ADDENDUM 01

DATE: July 24, 2014
TO: Continental 294 Fund LLC
FROM: Scott Tabary
Duplantis Design Group, PC
SUBJECT: Spring at Fremaux Town Center
Slidell, LA

MISCELLANEOUS CHANGES, ADDITIONS AND CORRECTIONS TO DRAWINGS:

DRAWN DGS
CHECKED DEB
ISSUED DATE 7/24/14
ISSUED FOR PERMITTING
PROJECT NO. 14-248
FILE 14-248 C-3 SITE
SHEET C-3.4

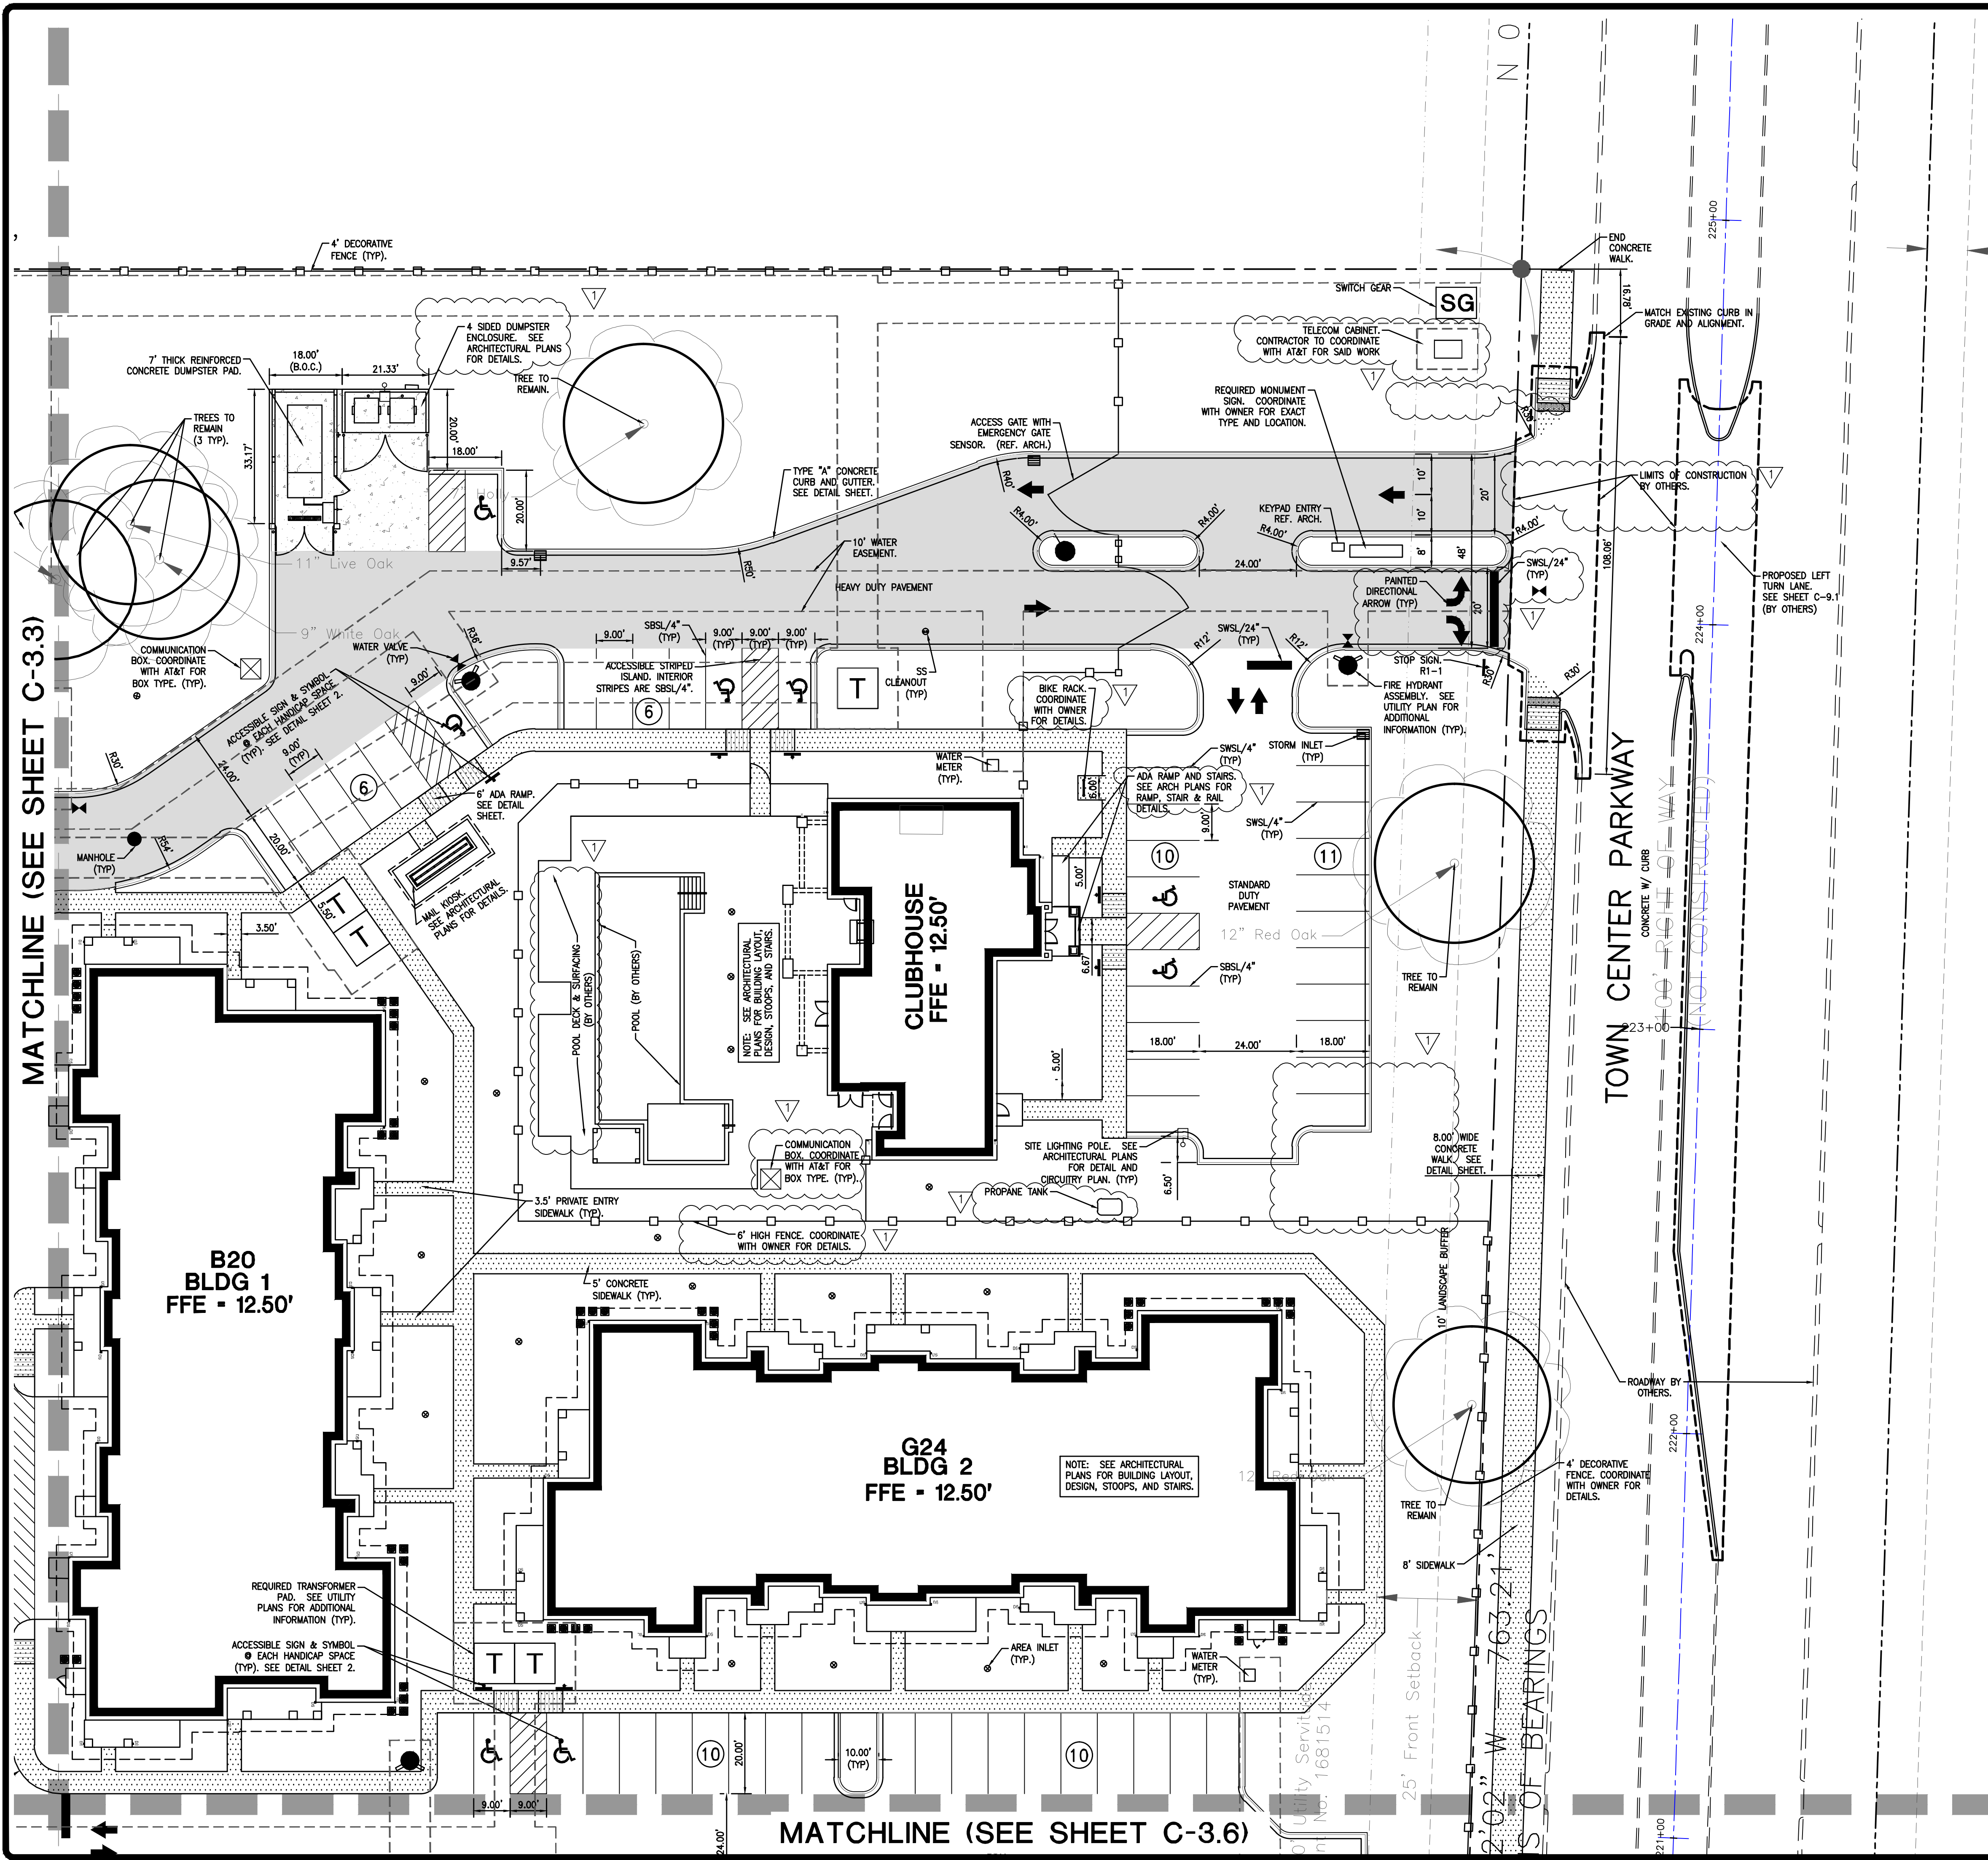
3. Added curb cut flumes at back of landscape islands. (Total of 2)
- G. Sheet C-3.4
1. Added Communication box callouts.
 2. Added water meter callout.
 3. Removed curb cut flumes at back of landscape islands. (Total of 2)

4. Added Tree to Remain callout.
 5. Added Note for contractor to coordinate with owner on Proposed Pergola.
- H. Sheet C-3.5
1. Added 4 sided Dumpster enclose note.

DRAWN DGS
CHECKED DEB
ISSUED DATE 7/24/14
ISSUED FOR PERMITTING 14-248
FILE 14-248 C-3 SITE
SHEET C-3.5

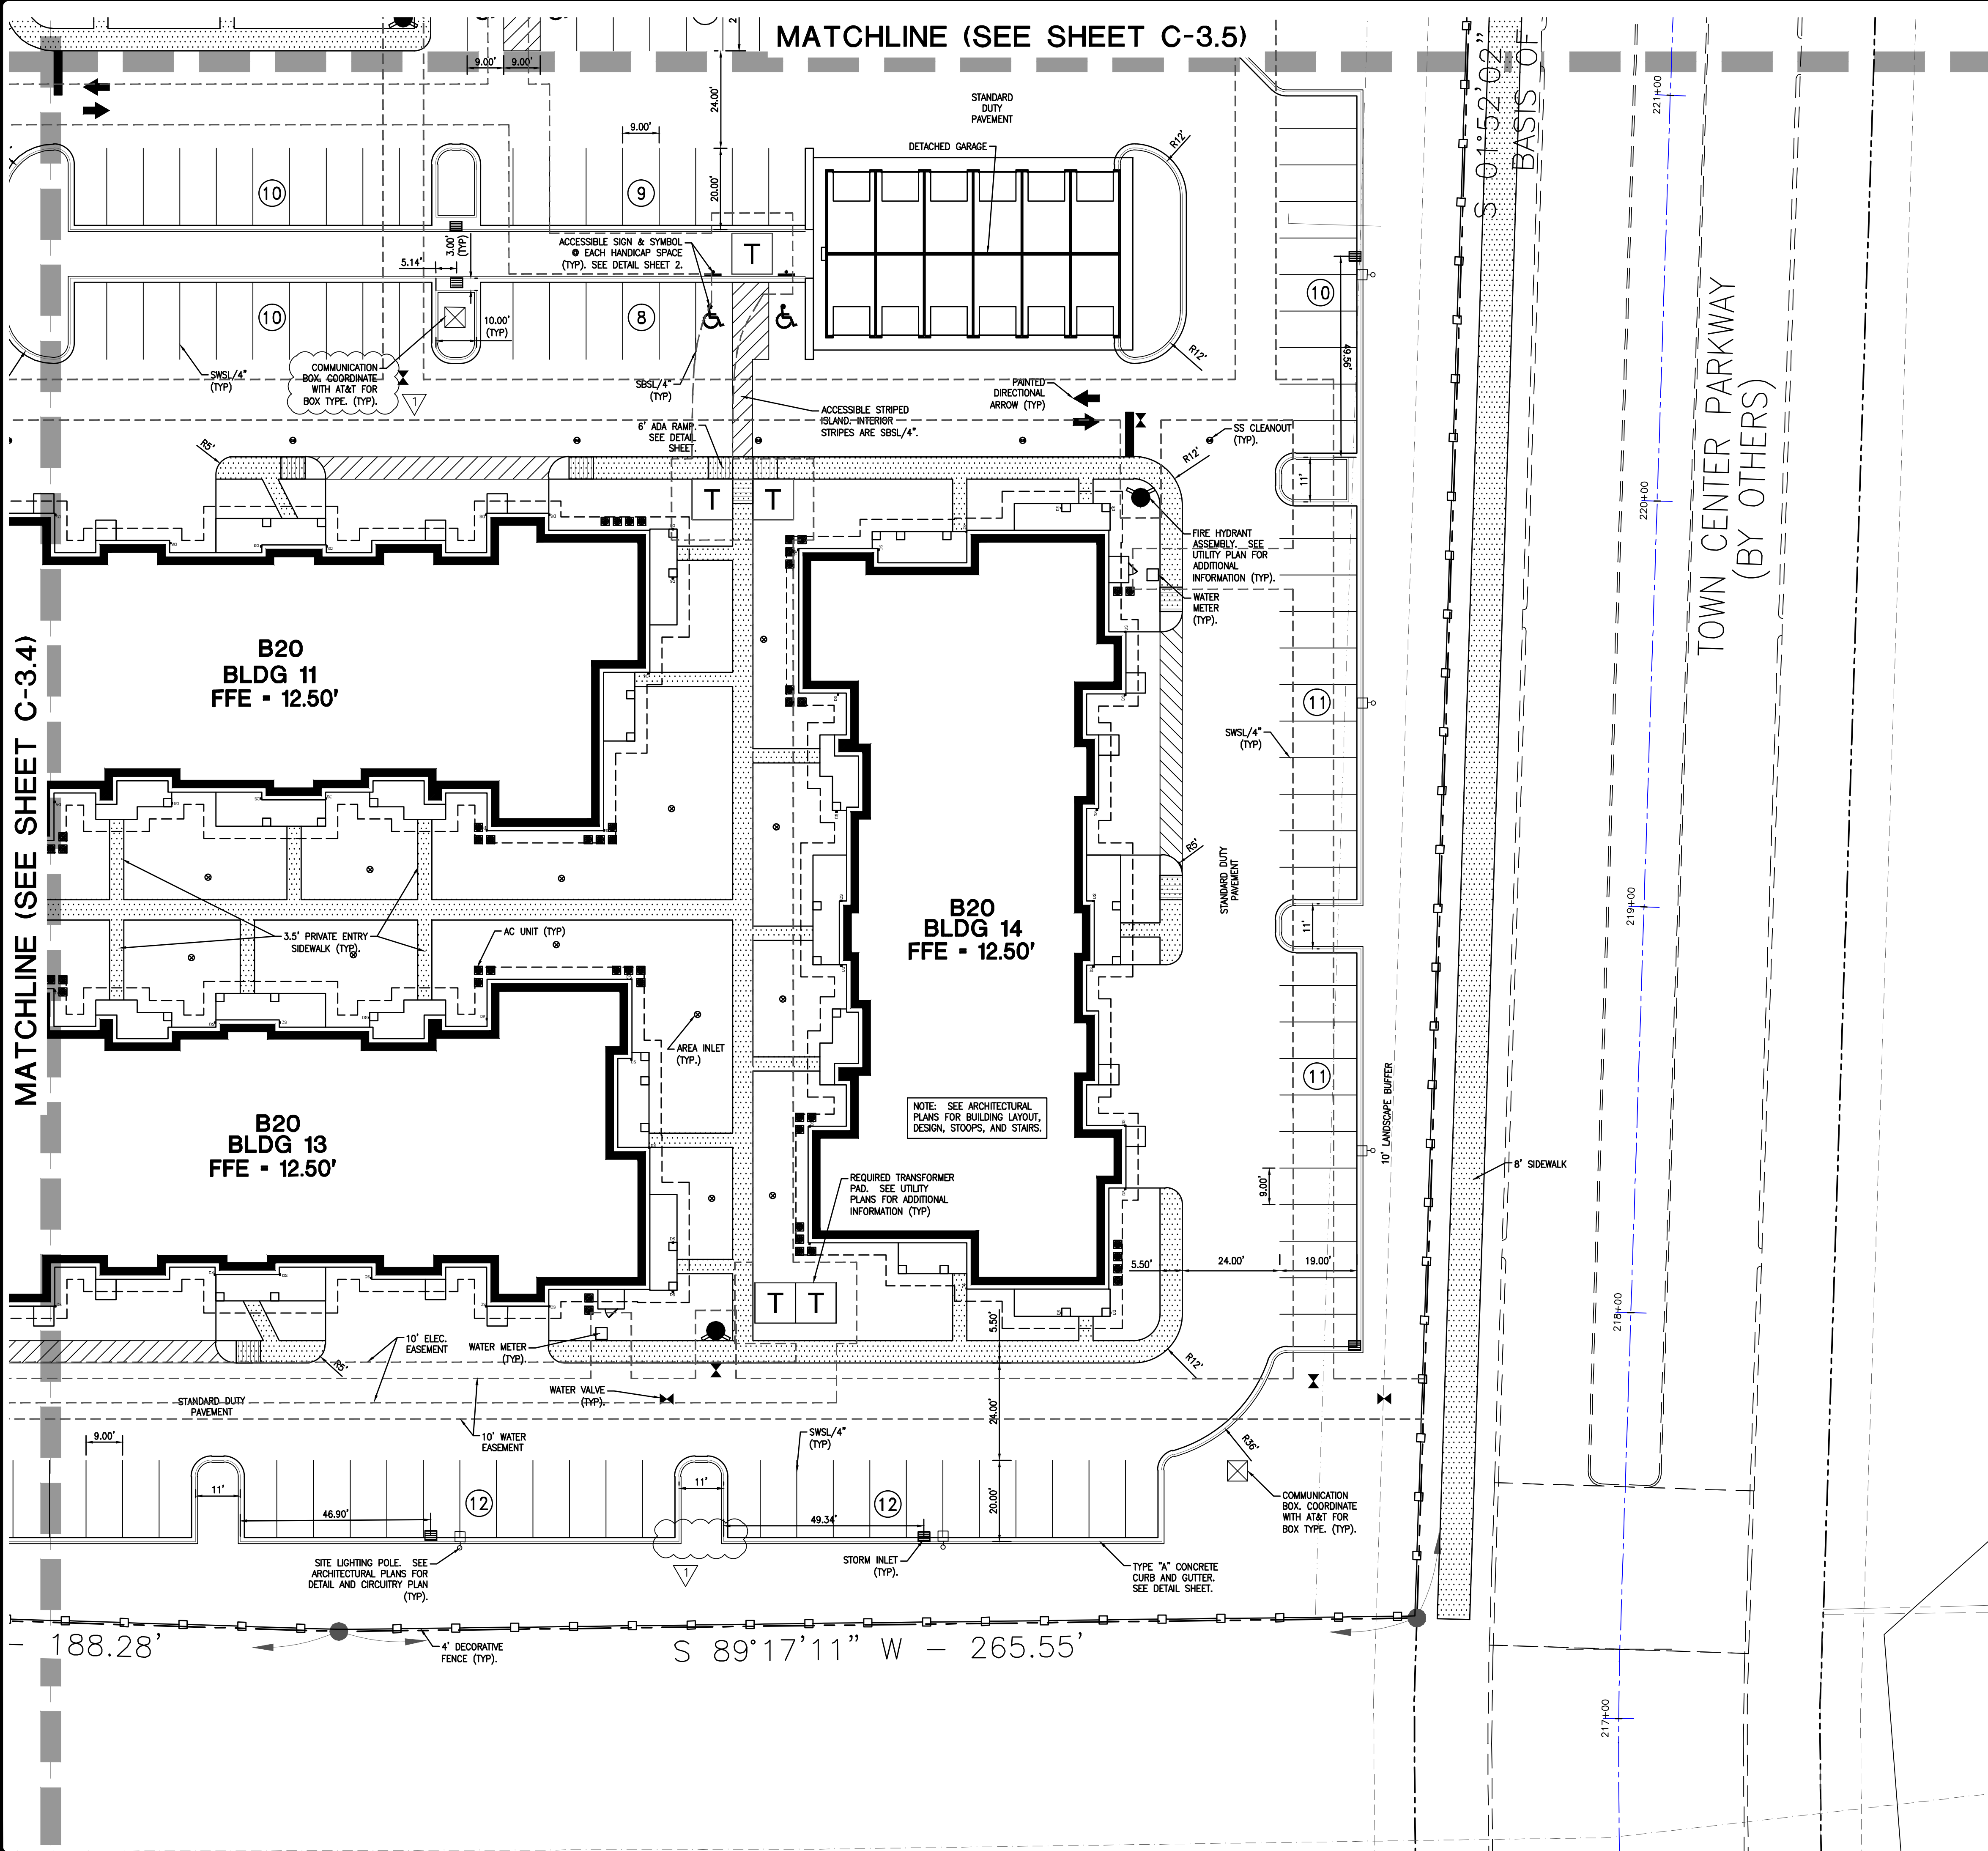
2. Added note stating, "Pool Deck and Surfacing(by Others)."
 3. Clarified 6' Fence note around pool area.
 4. Added propane tank location.
 5. Added Communication Box Note.

6. Existing tree at SE corner of club house parking area to be removed.
 7. Added Limits of construction note and updated legend with note stating where site contractor's work ends along Town Center Pkwy.

8. Added Telephone Cabinet coordination note.
- I. Sheet C-3.6
1. Added Communication Box Note.
 2. Removed curb cut flumes at back of Landscape Island. (Total of 1)

DRAWN DGS
CHECKED DEB
ISSUED DATE 7/24/14
ISSUED FOR PERMITTING
PROJECT NO. 14-248
FILE 14-248 C-6 UTILITY
SHEET C-6.4

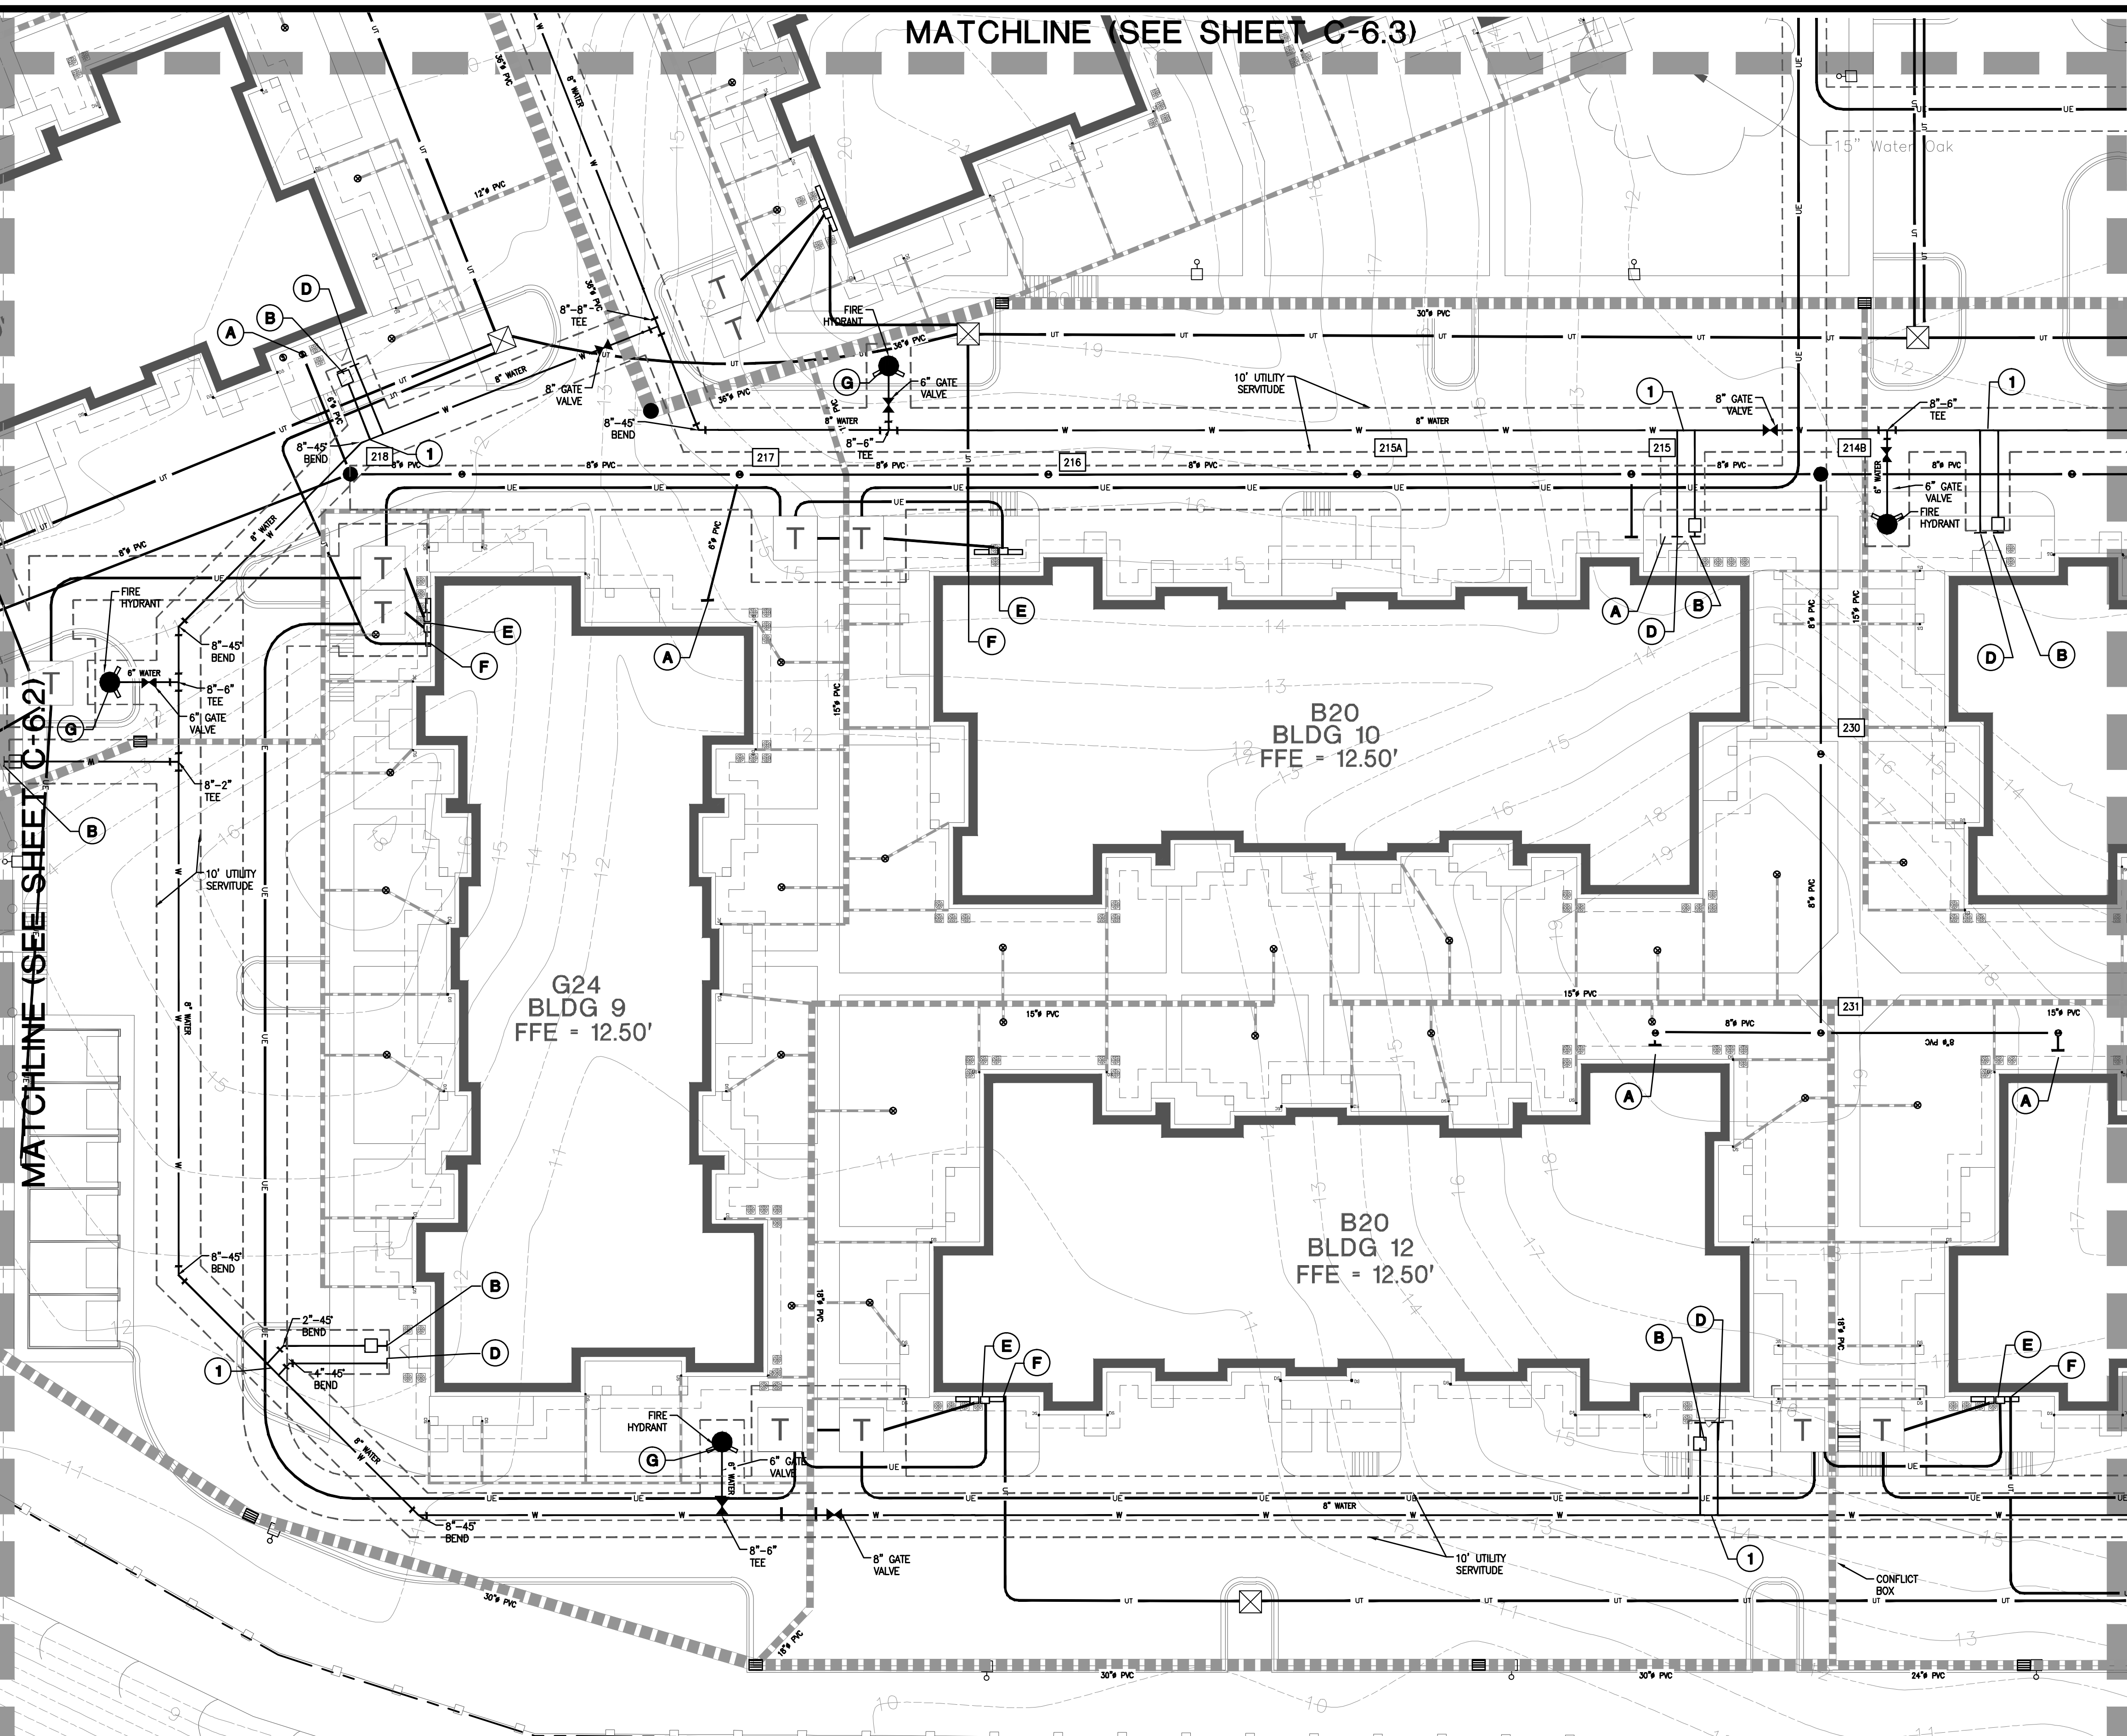
- M. Sheet C-6.0
1. Typical water entry detail has been updated.
- N. Sheet C-6.1
1. Added typical water entry detail callout.
- O. Sheet C-6.3
1. Switched Structure 228 from Manhole to Cleanout

2. Added typical water entry detail callouts.
 3. Moved Conflict Box callout to point to conflict box.
